Background

Models Affected

Improvements

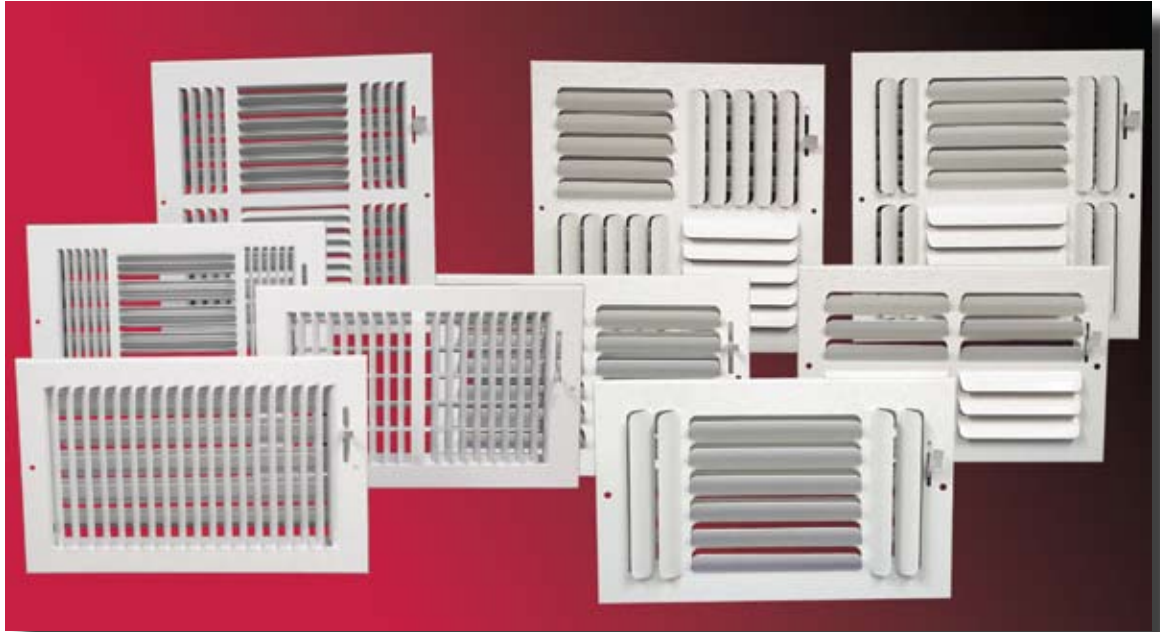
Improvements consist of a new rivet-free face and new 1" damper blades.

Previous models riveted the damper box to the diffuser face. Spot welding now creates a cleaner look.

Previous models used 2" damper blades. New 1" blades extend less obtrusively into shallow duct applications.
